SUBJECT: LIMERICK GENERATING STATION, UNITS 1 AND 2 (TAC NOS. M91740
AND M91741)

These amendments eliminate the TS active safety function designation of eight (i.e., four per unit) Drywell Chilled Water System valves.

SAFETY EVALUATION BY THE OFFICE OF NUCLEAR REACTOR REGULATION

LIMERICK GENERATING STATION, UNITS 1 AND 2

DRYWELL CHILLED WATER SYSTEM PENETRATIONS
(TYPICAL)

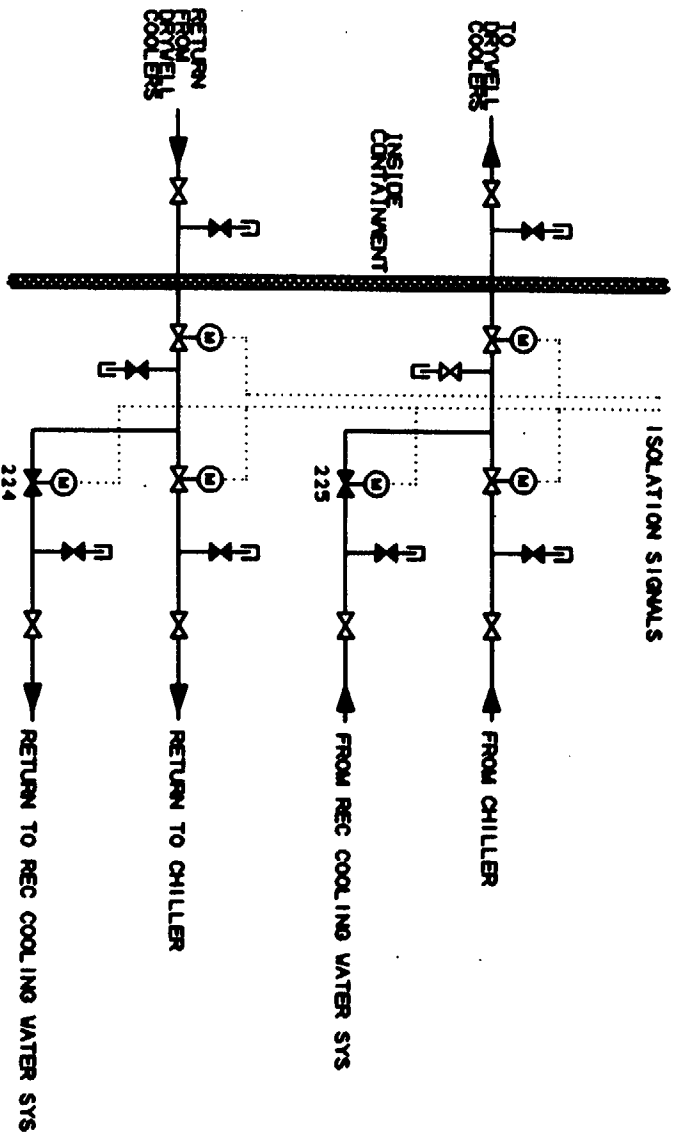
The DCWS in each unit supplies chilled water at 50°F temperature for equipment cooling inside the primary containment. This equipment includes unit air coolers' coils, the sump drain cooling coil, recirculation pump motor air coolers, drywell equipment drain sump cooling coil, sample coolers and vacuum pump seal cooler. The DCWS also supplies cooling to other equipment outside the drywell. The DCWS has a backup (non-chilled) water supply from the Reactor Enclosure Cooling Water (RECW) System. Neither the DCWS or RECW System is safety-grade. In the event of an accident, containment cooling is provided by the Engineered Safety Feature, containment heat removal systems. The DCWS/RECW containment penetrations are arranged as shown in the enclosed figure.

The valves identified as "224" and "225" in the attached drawing (four valves per unit) are classified as containment isolation valves and have maximum allowable closure time limits specified in the Technical Specifications for plant operations in Modes 1, 2 and 3. The licensee proposes to remove the automatic isolation relays for these valves and to lock the valve operator circuit breakers in the open position. The relays to be removed are devices which, when deenergized by an automatic isolation signal, cause the valve operators to close the valves if they are open. These modifications, along with administrative controls, will preclude the valves being open during Modes 1, 2 and 3. Thus the automatic closure feature will be unnecessary. The

valves will remain classified as isolation valves since they will still have a passive isolation function. The deenergization of the valve operator power source makes each valve a passive "sealed-closed barrier" as defined in Standard Review Plan Section 6.2.4, paragraph II.f. This eliminates the need for operability and surveillance testing of the automatic closure feature. The effect of locking open the valve operator circuit breakers removes the RECW system as a backup water supply. This is acceptable since both systems are non-safety. However, all aspects of Appendix J leak testing requirements of these two valves will remain in effect.

The licensee's modifications will eliminate the "active safety function to close" feature of the "224" and "225" valves. This feature can be eliminated because the RECW backup water supply to the DCWS system is not a safety requirement. As a result of eliminating the active isolation feature, the TS operability and surveillance requirements associated with automatic isolation are unnecessary. Therefore, based on the staff's review, the licensee's modifications are acceptable.

34. Auto isolation signals have been removed from HV-087-124 A/B and 125 A/B. Valves to be closed with associated circuit breakers locked open during OPCONs 1, 2, and 3.

34. Isolation signal causes recombiner to trip; valve closes when recombiner is not operating.
 35. Auto isolation signals have been removed from HV-087-224 A/B and 225 A/B. Valves to be closed with associated circuit breakers locked open during OPCONS 1, 2, and 3.
